Everett Riverfront Redevelopment DEIS Errata
January 3, 2008

You were recently provided a copy of the DEIS for the Everett Riverfront Redevelopment. Attached are several corrected figures for the DEIS:

Figure 5.1-4

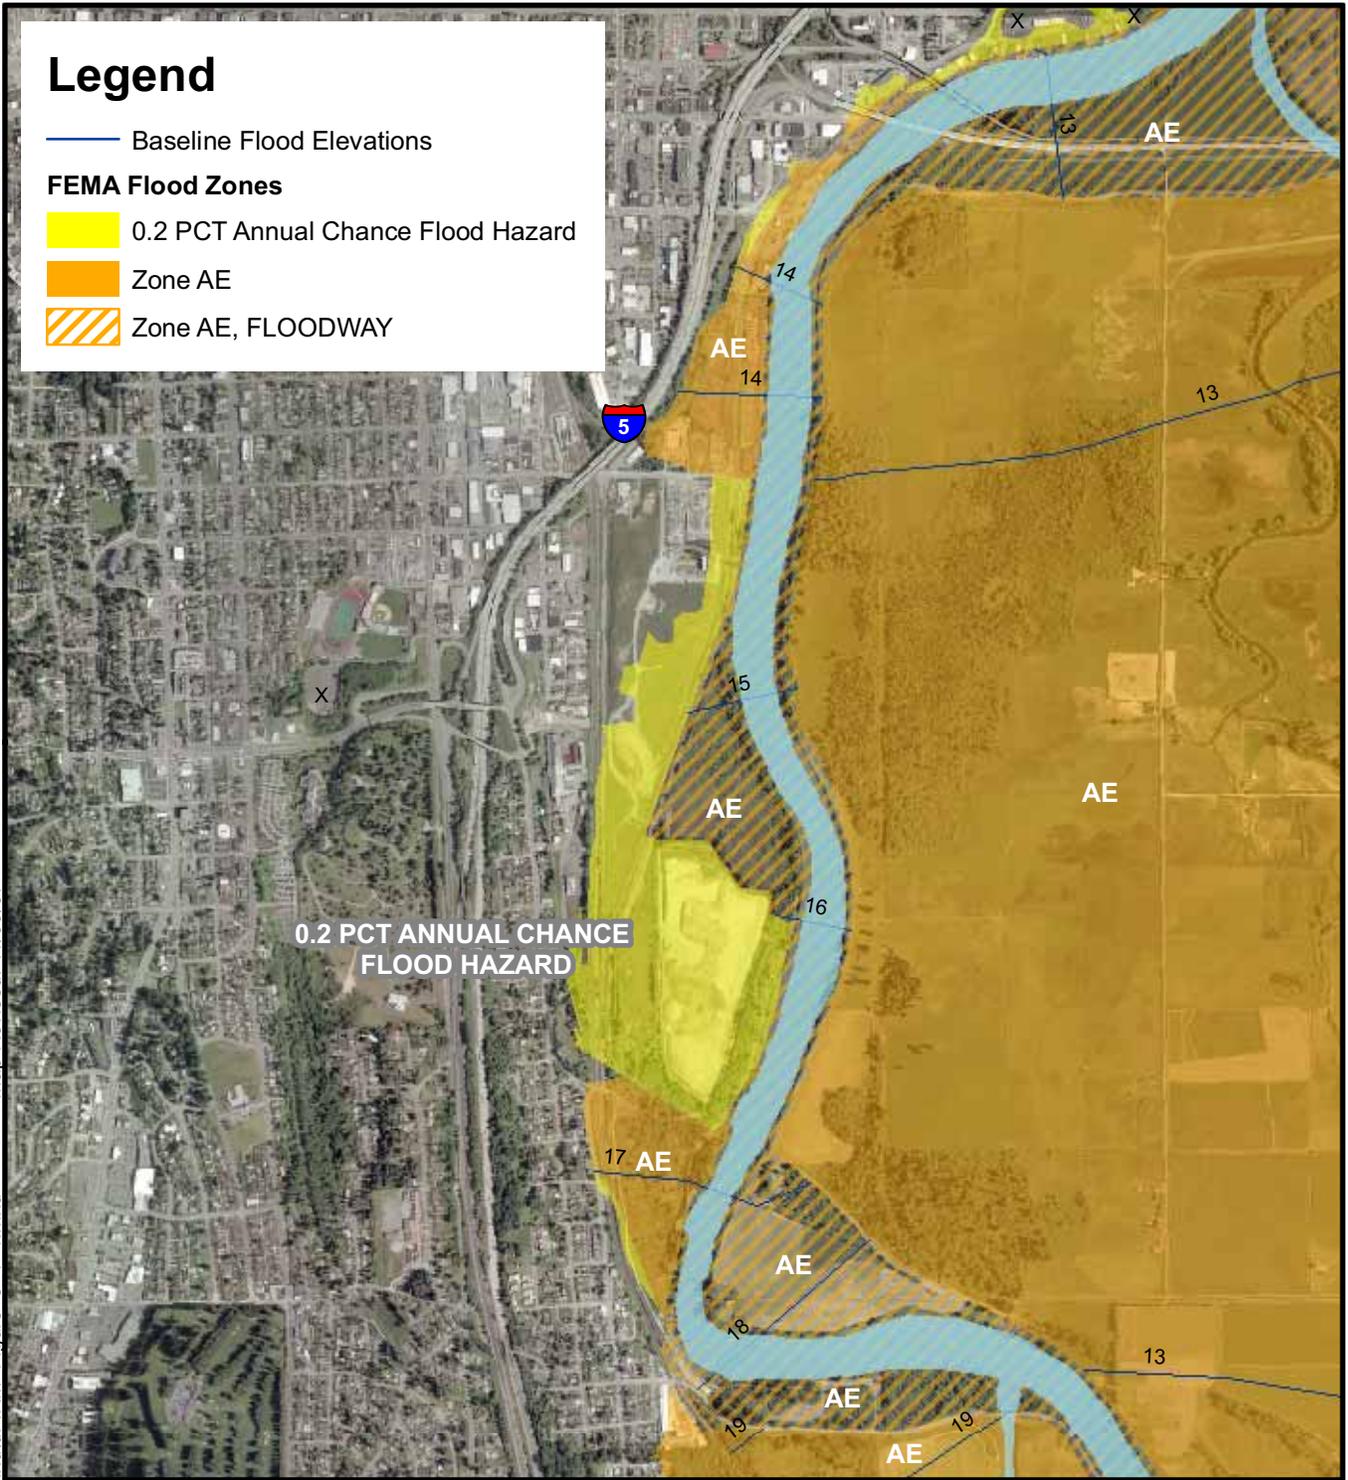
- The 1947 aerial photo was not included in Section 2.1 and the 2006 aerial was included twice. Please add Figure 2.1-4A after Figure 2.1-3.
- The legends in Figures 2.3-1, 2.3-1A and 2.3-1B did not match the colors on the figures. Revised figures are provided.
- Figure 5.1-4 (page 5-13) showed an incorrect floodway boundary at the north end of the Simpson Pad.
